**Kemps Creek Warehouse, Logistics and Industrial Facilities Hub (SSD-9522)  
Request for Additional Information**

## **Attachment 1 - DPIE Industry Assessments and Central (Western) comments**

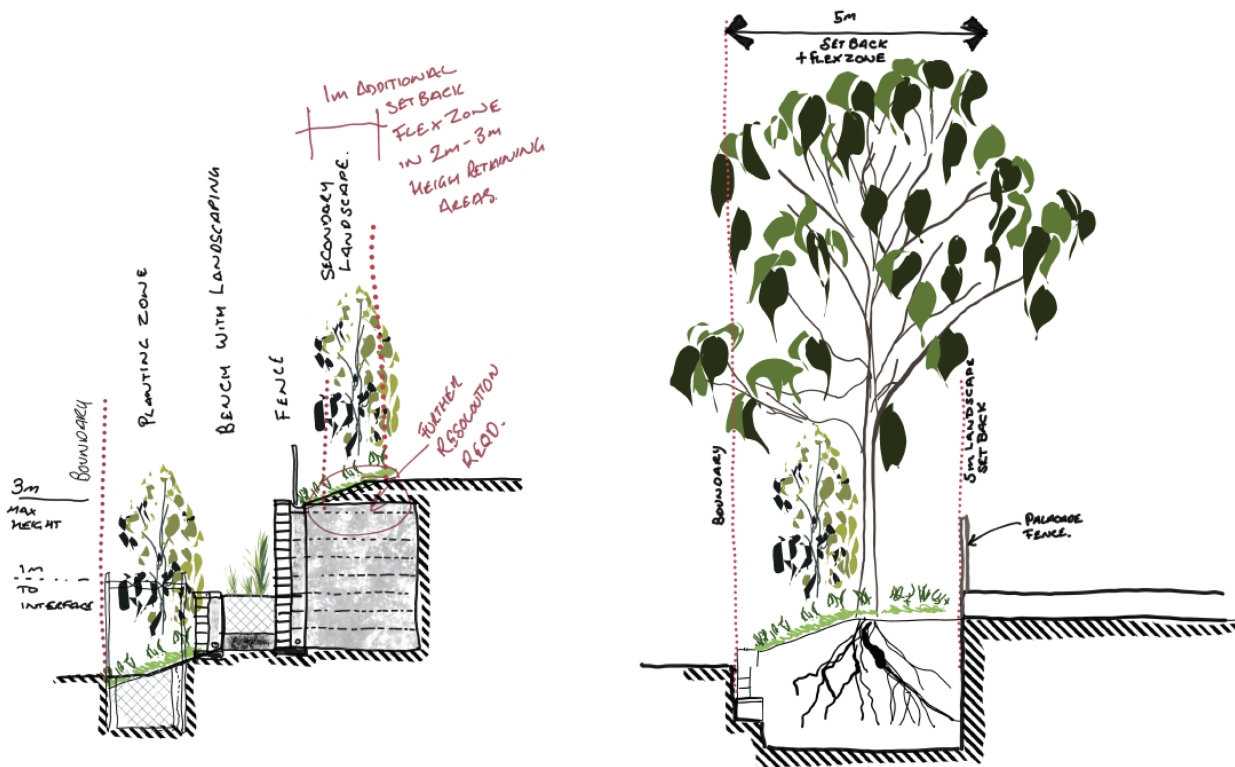
- The Applicant could consider a batter and multi-benched retaining system within a 5m 'flex zone'. The flex zone would treat the interface according to the topographical falls on the site (rather than a fixed, one approach retainer across the extensive southern border). A multi-benched retaining system which sets back the additional height away from the property boundary into the flex zone could be used where a retaining wall of greater than 1m is required. This approach would allow shadows to be minimised to RE1 and any paths to the south of the development, the preservation of deep soil planting and flexibility to be built into the scheme. Further, the development hardstand would be responsive to the topography. A sketch is provided for discussion (below).
